MFN 07-192

Subject: **Response to Portion of NRC Request for Additional Information
Letter No. 26 - Isolation Condenser System - RAI Numbers
5.4-22 S01, 5.4-29 S01, 5.4-32 S01, 5.4-41 S01, 5.4-42 S01, and
5.4-52 S01**

Isolation Condenser System

Figure 5.1-3a. Isolation Condenser System Schematic

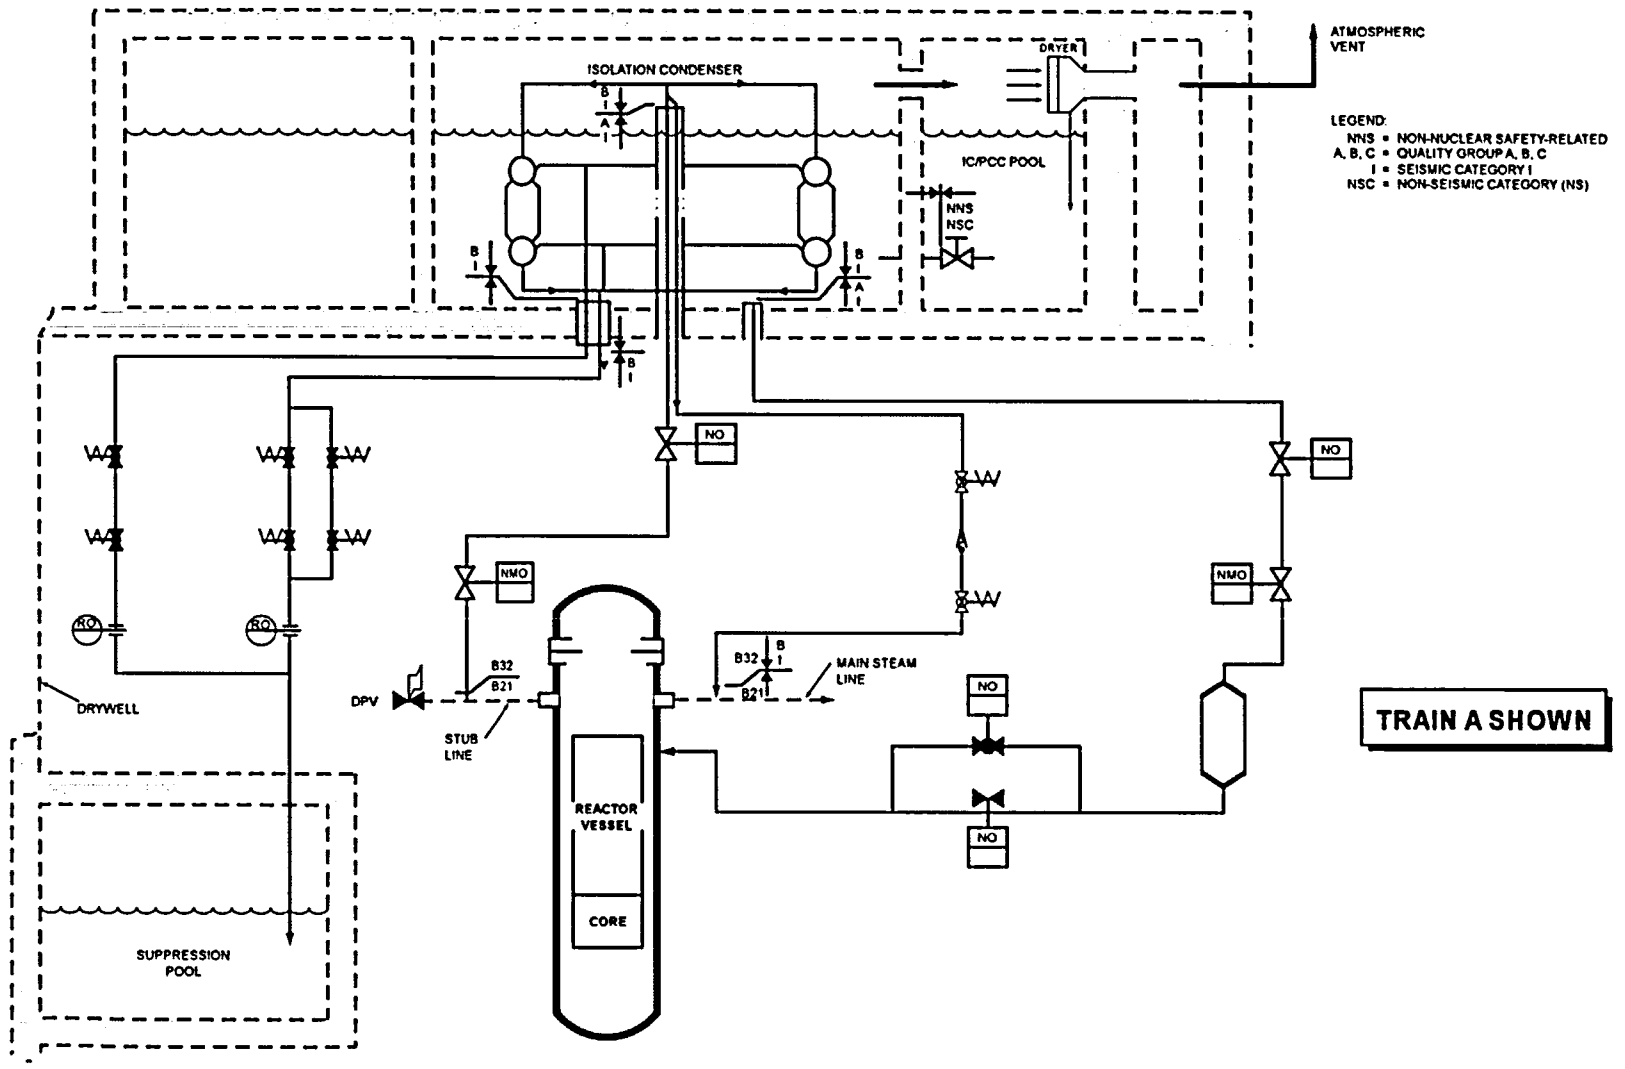
Provide the information in GE's response to 5.4-25 (MFN 06-249) in the DCD Tier 2. Also, include the schematic of the isolation condenser.

DCD Tier 2, Figure 5.1-3, will be renumbered as Figure 5.1-3a in DCD Tier 2, Revision 4, as shown in the attached markup. DCD Tier 2, Figure 5.1-3b, will be incorporated in DCD Tier 2, Revision 4, to provide the front view schematic of the IC, as shown in the attached markup. DCD Tier 2, Figure 5.4-4, will be relocated as Figure 5.1-3c and revised in DCD Tier 2, Revision 4, as shown in the attached markup (see response to RAI 5.4-22 S01 for further details).

Figure 5.4-41-3c. Isolation Condenser System Simplified Process Diagram

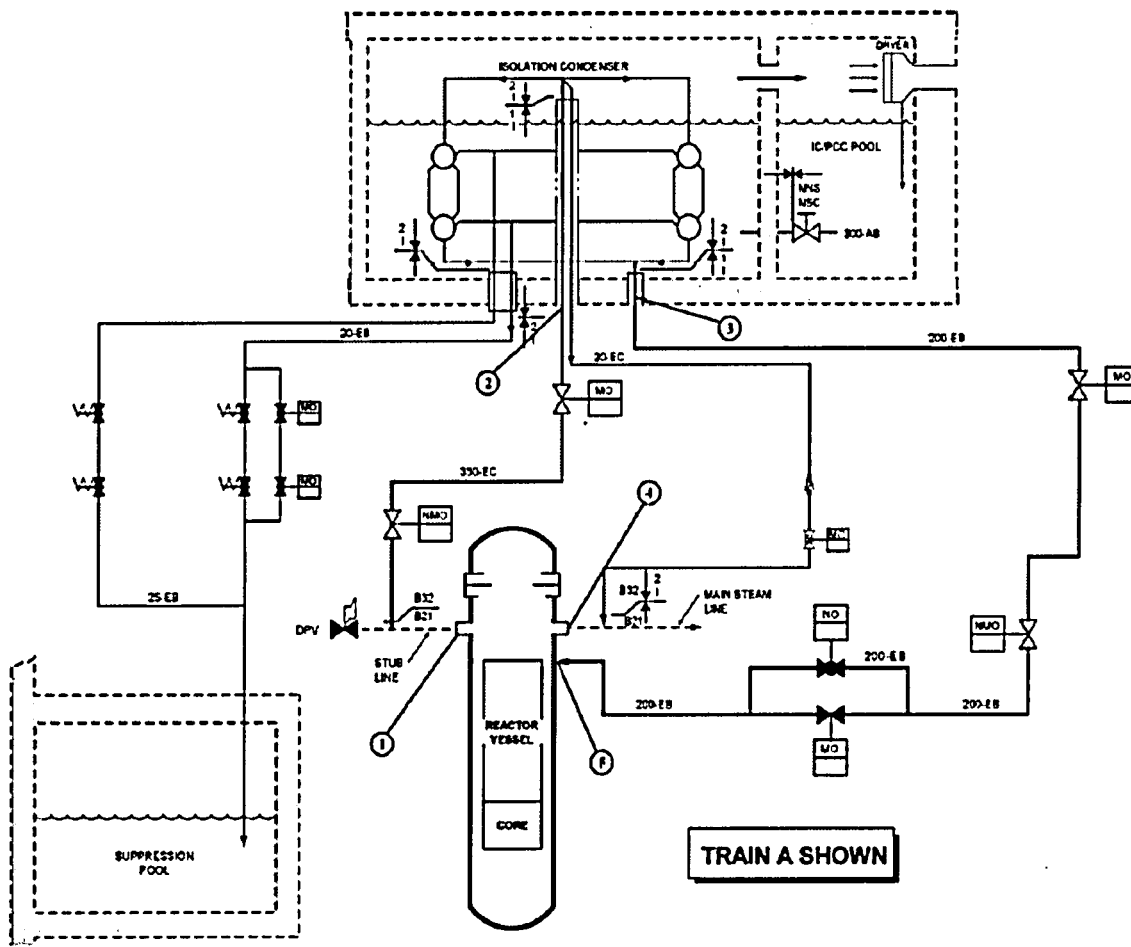
- (A) Please include the isolation condenser system (ICS) design parameters in the process diagram.*
- (B) In the standby mode, temperature in the condensate return line (node 3) appears to be high. Please explain this high temperature.*

- (A) The Isolation Condenser System (ICS) Process Flow Diagram design parameters provided in response to RAI 5.4-22 (MFN 06-265) will be included in DCD Tier 2, Figure 5.1-3c, in Revision 4.
- (B) Node 3 has a condensate temperature of 99.7°C at the Isolation Condenser (IC) lower headers. To add margin in the IC/Passive Containment Cooling (PCC) pool water volume, the conservative assumption was made to set the IC/PCC pool water to its saturation temperature. Therefore, the IC/PCC pool temperature affects node 3.

- (A) DCD Tier 2, Figure 5.4-4, will be relocated as Figure 5.1-3c and revised in DCD Tier 2, Revision 4, as shown in the attached markup (see response to RAI 5.4-29 S01 for further details).
- (B) No DCD changes will be made in response to this RAI.
